Addendum No. 2

Project: The Brando for Bluestone Development

Date: 18 April 2013
From: Studio 951, Ltd.
To: All plan holders.

X 10
1/2" = 1'-0" TYPICAL
DETAIL AT BIKE LOCKERS

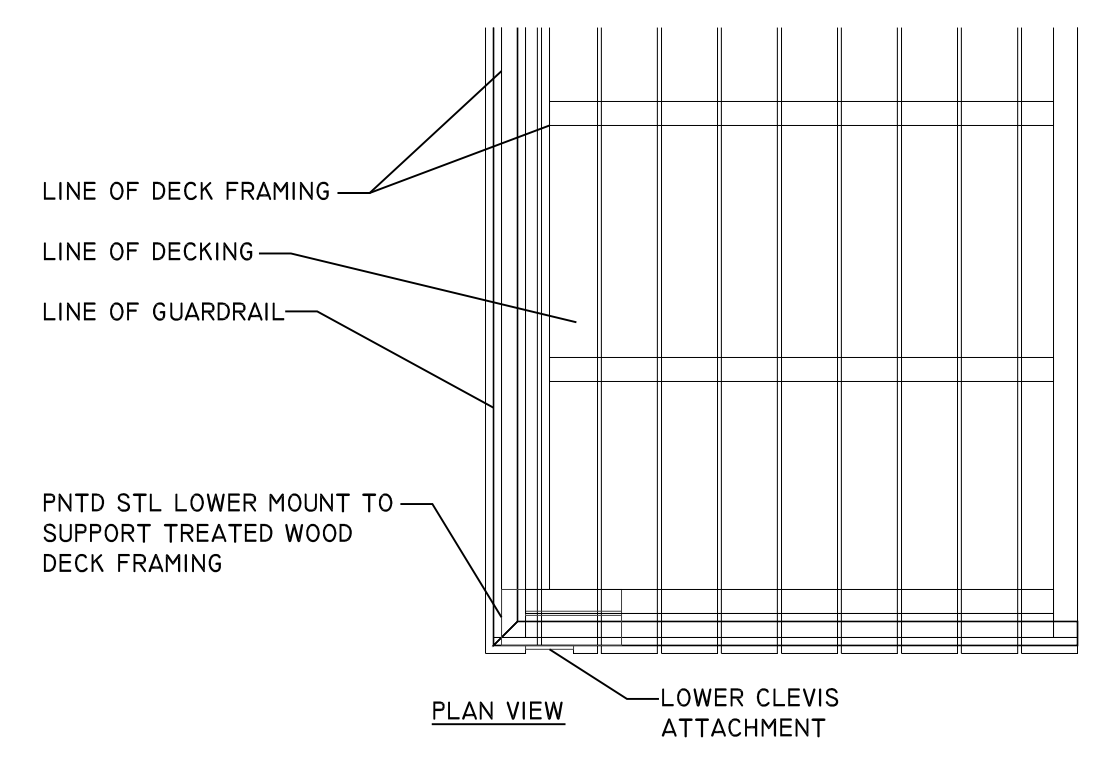
Detail tag X10/A2.10 has been added at the bike locker locations. Please note the bike locker locations shown here are typical of the floors above as well.

R 1
M4.01

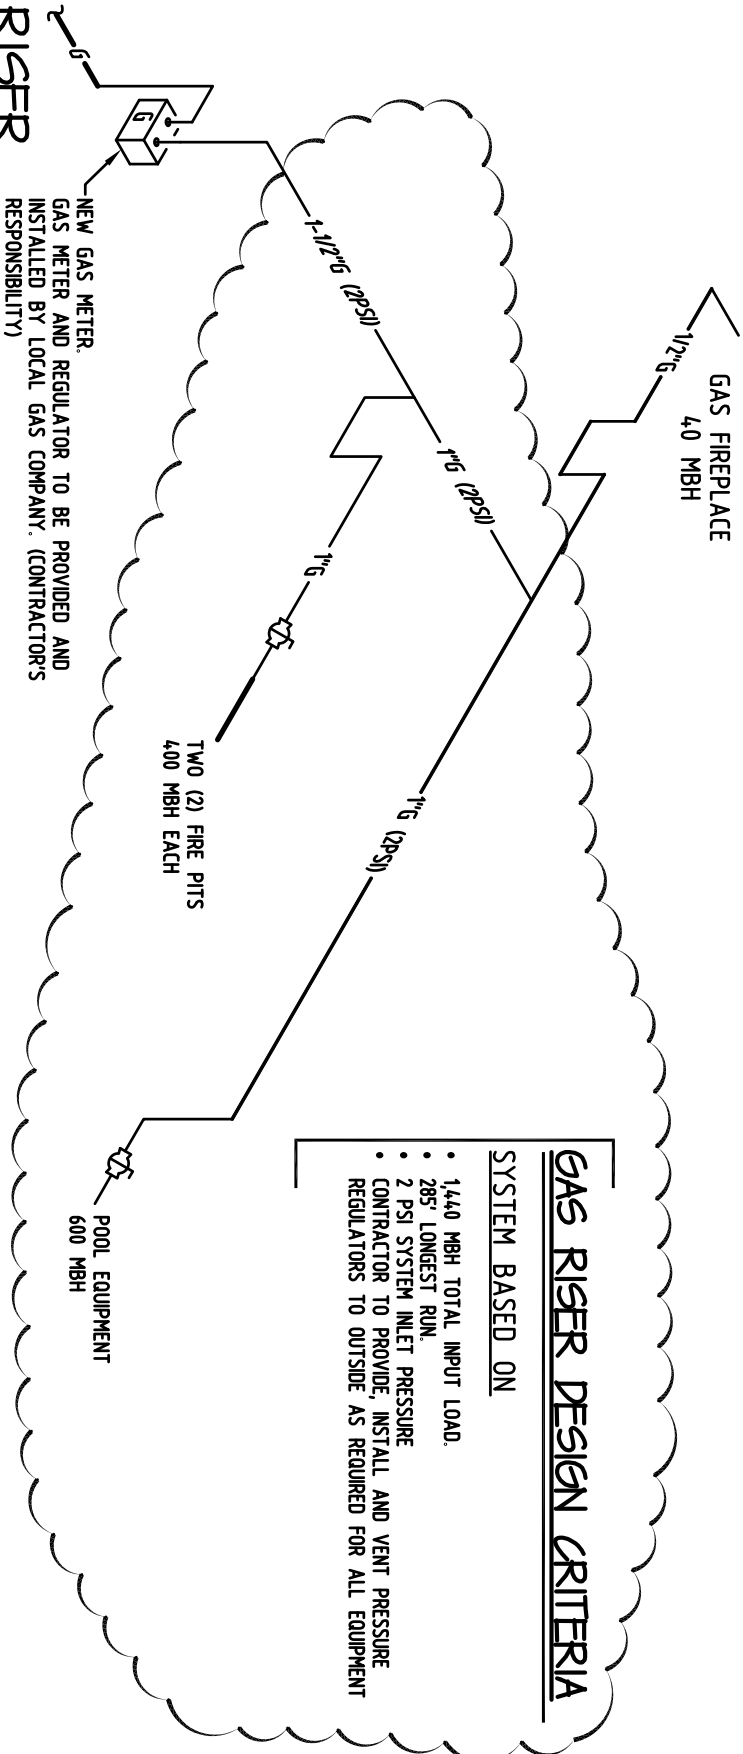
- a. See attached supplemental drawing for revised gas loads and sizes. Gas sizing on gas riser shall be reflected on floor plan sheets.

- 1,440 MBH TOTAL INPUT LOAD.
- 285' LONGEST RUN.
- 2 PSI SYSTEM INLET PRESSURE
- CONTRACTOR TO PROVIDE, INSTALL AND VENT PRESSURE REGULATORS TO OUTSIDE AS REQUIRED FOR ALL EQUIPMENT
